Preview - SDA_113217Source Language ▼**Question**

Mandatory: Leaking water from the blowdown valve of Exprelia.

(Image2)

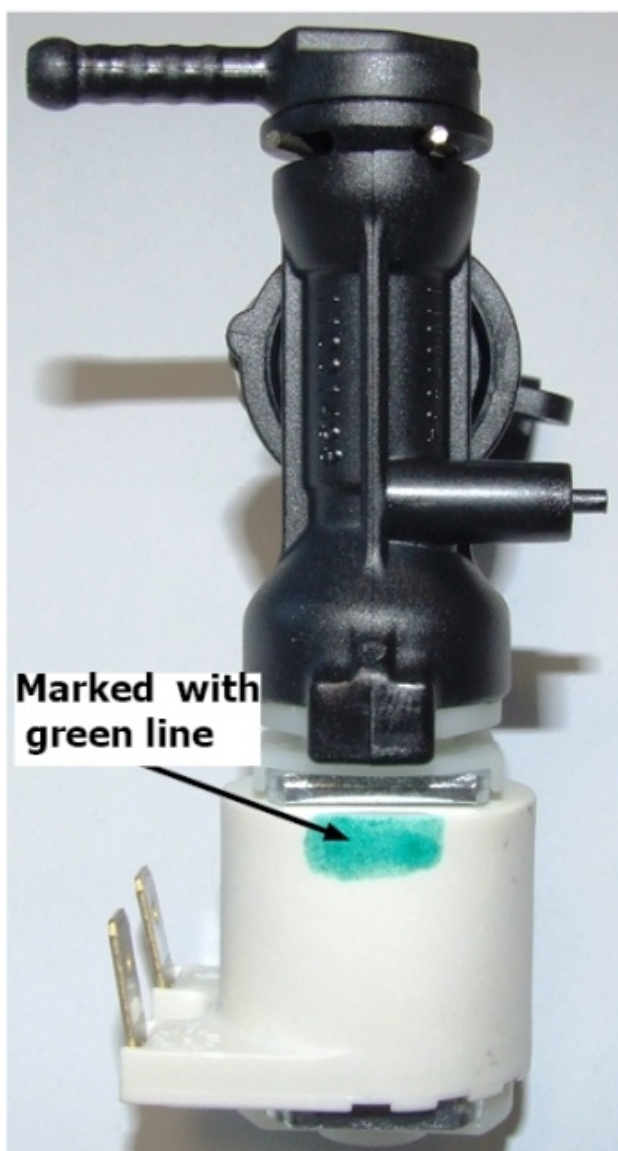
The valve will be delivered with a green line to make it recognizable. (Image2) to avoid replacement on repeat repairs.

**CURE:**In all machines Exprelia produced **up to. WK10 2015 mandatory** replace the:**421944039871 BLOWDOWN VALVE V3 MYB9 230V ASSY.****421944039911 BLOWDOWN VALVE V3 MYB9 120V ASSY.****421944039921 BLOWDOWN VALVE V3 MYB9 100V ASSY.****421944039931 BLOWDOWN VALVE V3 MYB9 220V-60HZ ASSY.**
